**SB-GA8-2014-116**

**Issue 2**

# Service Bulletin

Installation of a Secondary Starter Solenoid

**Figure 2:** View Looking Aft on Firewall

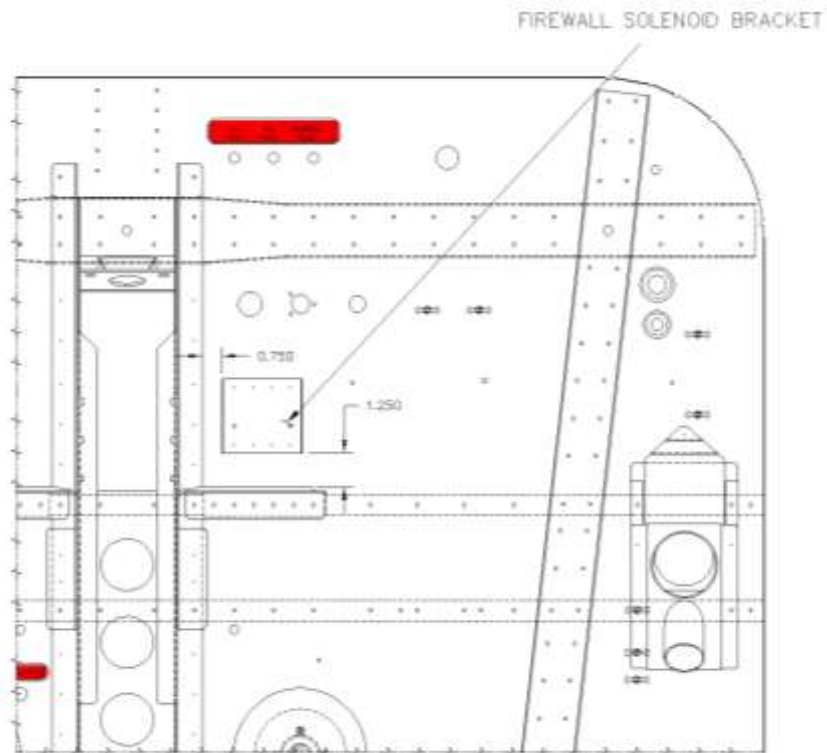
- 1.4. Locate and undo the Insulation Firewall Centre LH (GA8-258012-025) to provide access to aft face of the firewall in the area of the solenoid mounting. Retain the fastening hardware.
- 1.5. Place the Firewall Solenoid Bracket (item 1) in position as per Figure 2 and back drill the 8 x ø0.098" bracket mounting holes through the firewall. Open holes up to ø0.128" and clip in location.

**Figure 5:** Cable Routing, View Looking Inboard/Aft On Firewall LHS

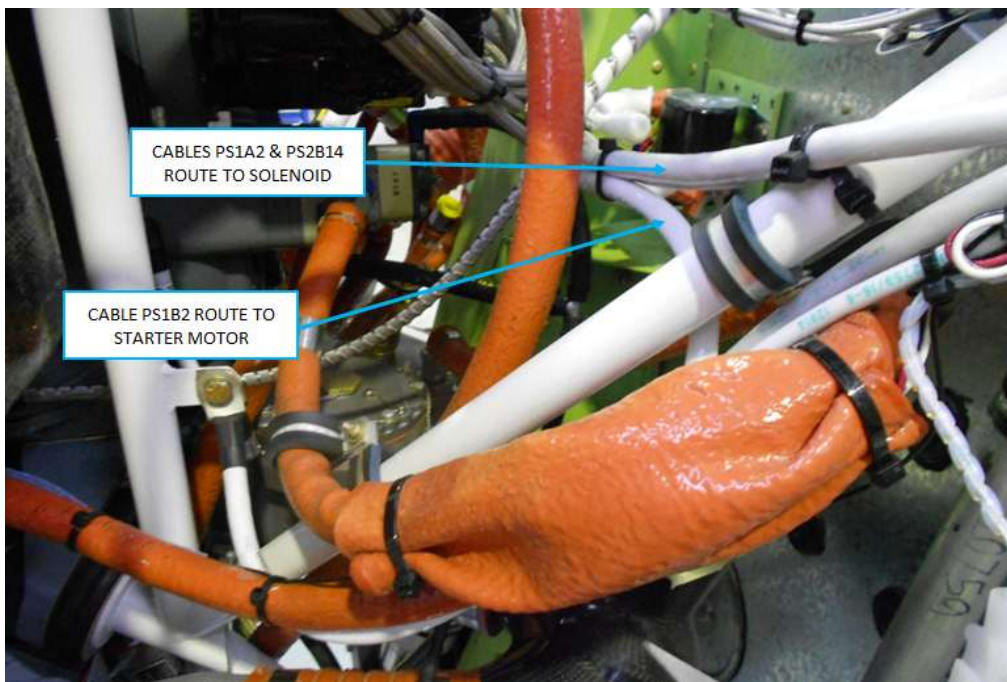
- 2.7. The cable assembled in step 2.5 is to be inserted through the supplied Terminal nipple (Item 11) and attached to the respective terminal of the solenoid with the hardware supplied. Torque to 20in-lb.
- 2.8. Slide the Terminal nipple into position. Refer to Figure 5 for the cable routing for PS1A2 & PS2B14 from firewall to Solenoid.

- 2.9. Using the supplied 55" length of 2 AWG White ETFE (MS22759/16-2-9), crimp the terminal ring red (Item 12) and heat shrink the sleeve to both ends. Label the cable PS1B2.
- 2.10. Slide the cable PS1B2 assembled in step 2.9 through the fire sleeve forward to the engine starter motor and attach with the hardware retained in step 2.2. Pass the other end through the supplied terminal nipple (Item 10) and attach to the outboard terminal of the solenoid with the hardware supplied. Slide the terminal nipple into position. For routing details refer to Figure 5.

**Figure 6: Original Configuration**

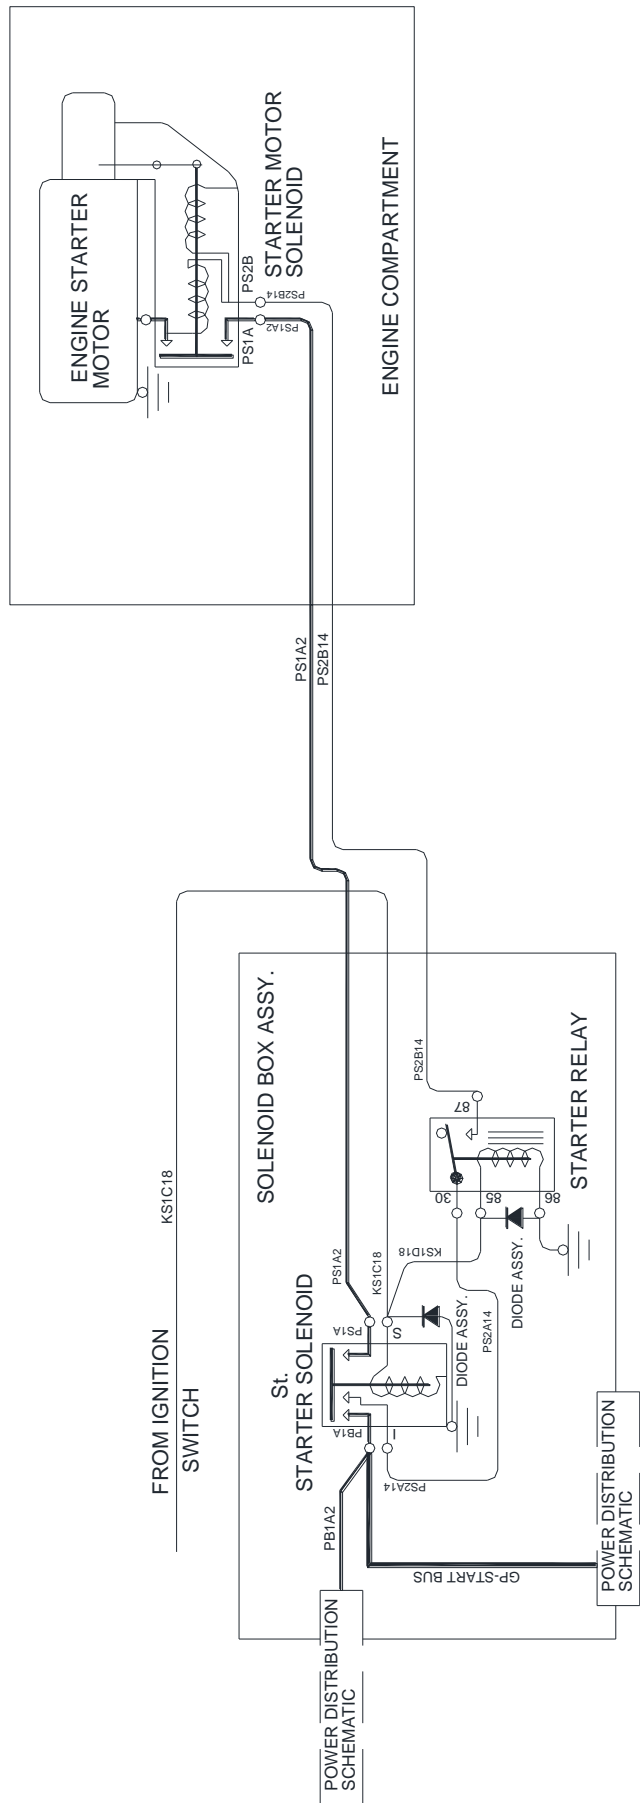
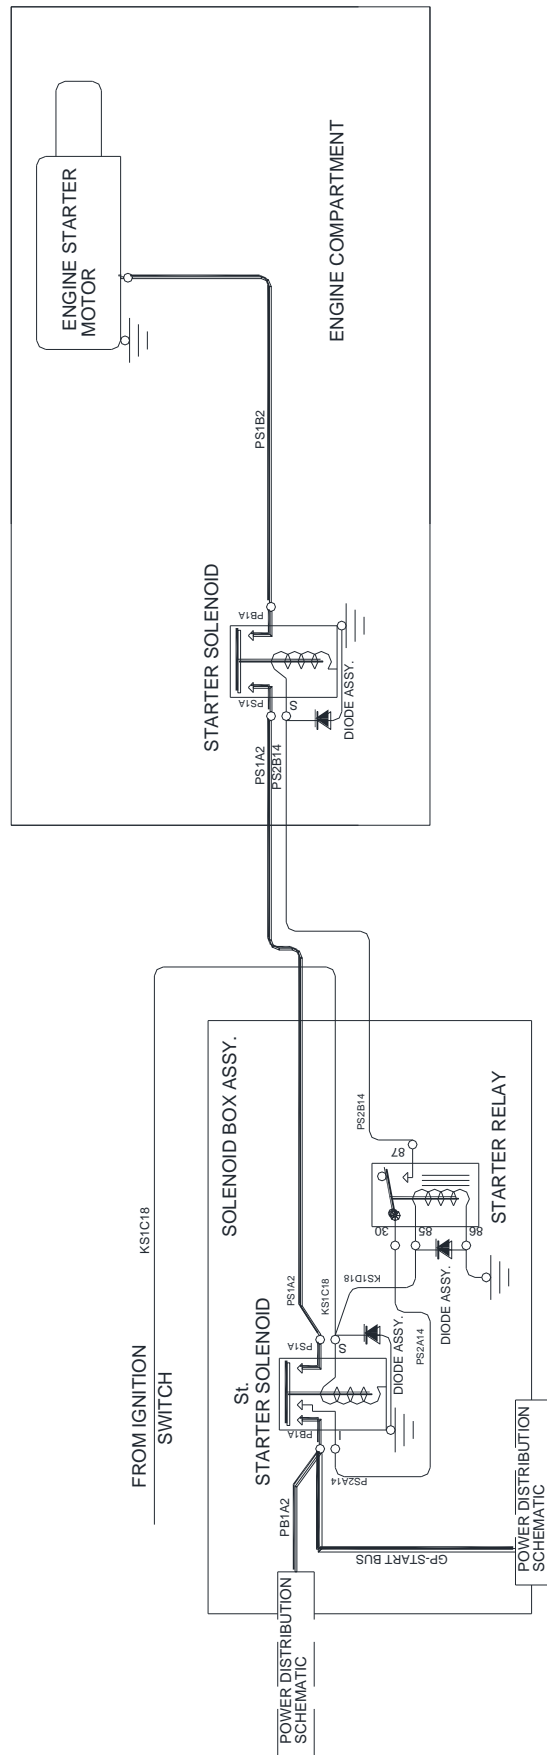
- 2.1. An overview of the original and modified wiring diagrams is shown in Figure 6 and Figure 7.
- 2.2. Refer to Figure 6, on the engine starter motor (mounted below the engine) locate the terminals PS1A & PS2B. Undo the cables attached to the terminals identified as PS1A2 & PS2B14. Retain hardware for reinstallation. Remove both cables through the existing fire sleeve back to the firewall.
- 2.3. Cut PS1A2 and PS2B14 to length for connection to newly installed solenoid.
- 2.4. Crimp the terminal ring (Item 12) to the PS1A2 cable and heat shrink the sleeve.
- 2.5. Crimp the terminal ring (item 13) to the PS2B14 cable and heat shrink the sleeve.
- 2.6. Pass the cable assembled in step 2.4 through the supplied Terminal nipple (Item 10) and attached to the respective terminal of the Solenoid with the hardware supplied. Torque the nuts to 40in-lb.

**Figure 7: Modified Configuration**
